Southeast Alaska Conservation Council

Re: Comments on the Kensington Mine Draft Supplemental Environmental Impact Statement (DSEIS) based on the amendment to the 2005 Plan of Operation (POA1)

FIGURE 3: Failure events over time.

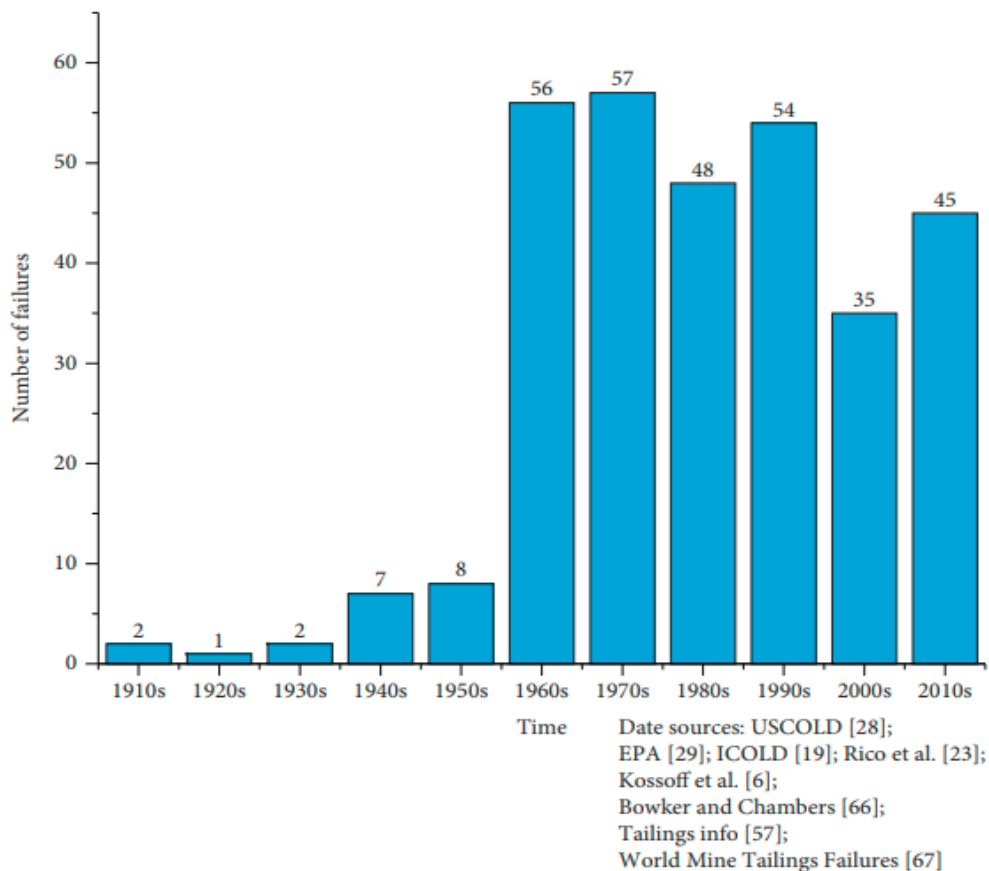
The DSEIS also uses data on dam failures from 1915 to the present. This also tends to unrealistically minimize the risk in light of the fact that there has been a substantial increase in the failure rate since 1960. See below:³⁵

The rate of dam failure has stayed much higher than the overall 1915-present average since 1960, and the failure rate after the year 2000 is currently five to six significant tailings dam failures annually.³⁶ As a consequence of failing to consider the local rate of dam failure and the recent increase in failure rates, the DSEIS again underestimates the probability of failure.
